Access Compliance Report

Public Rights-of-Way

Intersection ID: 24562	Main Street: CAVAN_CT	Cross Street: SWINFORD_PL	Location: SE
ADA ID: 58D314597BB1	Ramp Type: Perp	Initial Pass/Fail: Fail	Overall Compliance: No
		Severity Score: 10

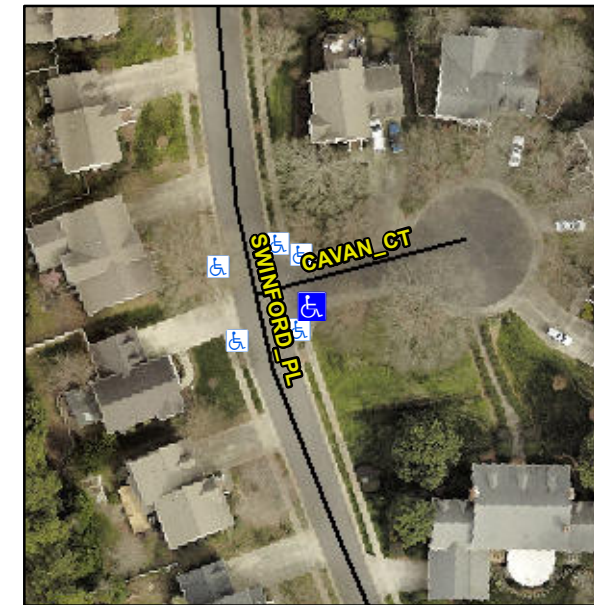
Not Found, R304.5.1, R304.5.3

Compliance	Description	Data	Compliance	Description	Data
N/A	Ramp Length (in)	48.0	Yes	Ramp Slope (%)	7.2
No	Ramp Width (in)	42.0	No	Ramp XSlope (%)	3.0
N/A	Flare Type LT	N/A	N/A	Flare Type RT	N/A
N/A	Flare Slope LT (%)	N/A	N/A	Flare Slope RT (%)	N/A
N/A	Flare Traversable LT?	N/A	N/A	Flare Traversable RT?	N/A
N/A	Landing Length (in)	N/A	N/A	DWS Provided?	N/A
N/A	Landing Width (in)	N/A	N/A	DWS Contrast?	N/A
N/A	Landing Slope (%)	N/A	N/A	DWS Length (in)	N/A
N/A	Landing X Slope (%)	N/A	N/A	DWS Full Width?	N/A
N/A	Landing Curb? (Y/N)	N/A	N/A	DWS Offset (in)	N/A
N/A	Shared Landing?	N/A			
N/A	Gutter Ponding?	N/A	N/A	Gutter Slope (%)	N/A
N/A	Gutter Lip Ht (in)	N/A	N/A	Gutter X Slope (%)	N/A
N/A	Painted X Walk1?	No	N/A	Painted X Walk2?	N/A
	X Walk 1 Direction	To N		X Walk 2 Direction	N/A
N/A	X Walk 1 Width (in)	N/A	N/A	X Walk 2 Width (in)	N/A
	X Walk 1 Slope (%)	1.4		X Walk 2 Slope (%)	N/A
	X Walk 1 X Slope (%)	2.9		X Walk 2 X Slope (%)	N/A

Remove & Replace Entire Ramp.
